# Building Code of Australia 2014

Summary Report for BCA Compliance

PROJECT NAME: Change of Use to No 33 Santley Crescent, Kingswood

DATE: 24 March 2015

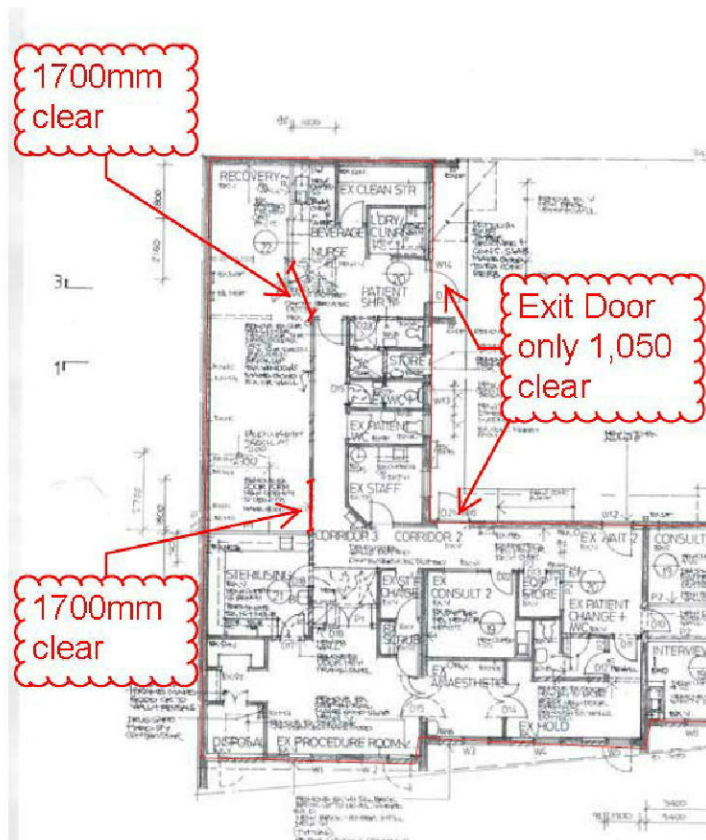
The current exit doors are the two exit doors identified on the below plan, these are the only two required exits from the patient care area. There are areas in the patient care areas that do not comply, as shown in below part of the building

- Fire Safety Engineering is to be undertaken to assess these existing provided doors and widths of corridors against the performance provisions of DP4, DP6, and EP2.2 and provide a Fire Engineers Alternative Solution report
